66319B-08

S E R V I C E N O T E

66319B - MOBILE COMMUNICATION DC SOURCE, DUAL-OUTPUT 15V/3A,12V/1.5A. GPIB

Power-On Self test Errors, Auto reboot, Blank display. No output Communication errors.
No communication when using the GPIB Interface.

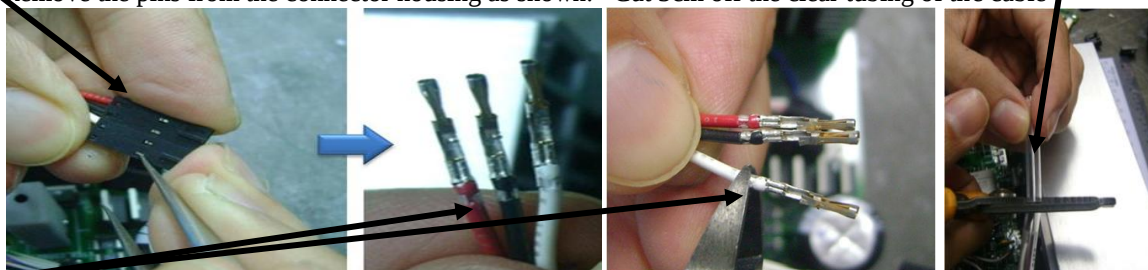
The instrument will exhibit the defects described above when the primary 5 volts drops below the design limits described. Poor crimping of the female connectors on the bias cable is the cause of the problem. The pictures below show in detail the female connectors having the problem.

The cable P/N 5080-2452 coming from the control board should be disconnected for the mail connector (circuit reference) "J206" which is soldered on the interface board.

Remove the connector P/N 1252-3695 (circuit reference) "J206" on the "A2" interface assembly. When removing "J206" care should be taken not to damage the "A2" printed circuit board material or the circuit board traces. "J206" has 4 holes remove the solder from these holes as shown. Do not apply too much heat or pressure this may cause damage to the PCA

The problem can be solved by soldering the cable wires directly into the interface printed circuit assembly “A2”. The following procedure describes in detail how to correctly solder the bias cable into the “A2” interface printed circuit assembly. (See manual link)

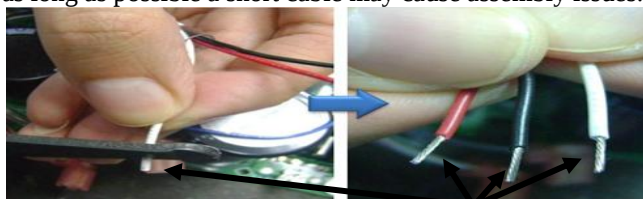
Remove the pins from the connector housing as shown. Cut 3cm off the clear tubing of the cable

Cut the crimped terminals at the crimp around the wires colored insulation. This is done so the cable length can be as long as possible a short cable may cause assembly issues.

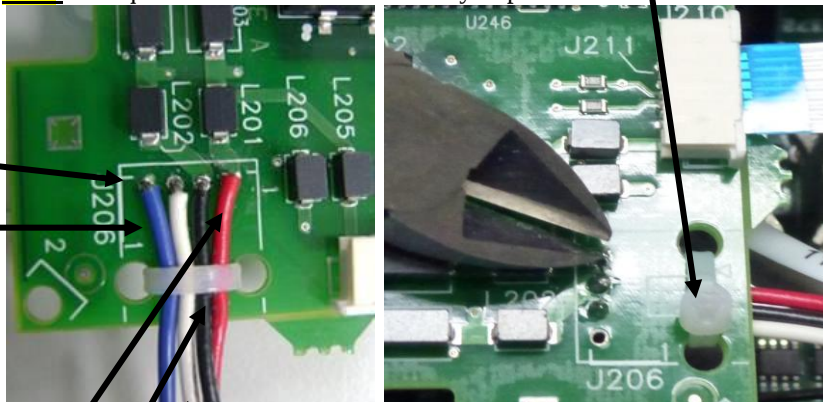
Insert the cable into the open holes located on the “A2” GPIB interface assembly.

Depending on the model there may be three or four wires.

The **Red** wire is soldered in the main control board (reference E320) and should be soldered into pin #1 or the square pad of “J206” on the “A2” interface assembly.

The **Black** wire is soldered in the main control board (reference E324) wire should be soldered into pin #2 of “J206” on the “A2” interface assembly. .

The **White** wire is soldered in the main control board (reference E321) should be soldered into pin #3 of “J206” on the “A2” interface assembly.

The **Blue** wire is required for the models shown below **ONLY**. This **Blue** wire comes from the connector on the battery emulation board P/N 5064-0131 circuit reference J001 Pin 12, the **Blue** should be soldered into pin # 4 of “J206” for the models listed below only. All other **66300X Mobile Comm DC Sources** only require 3 wires.
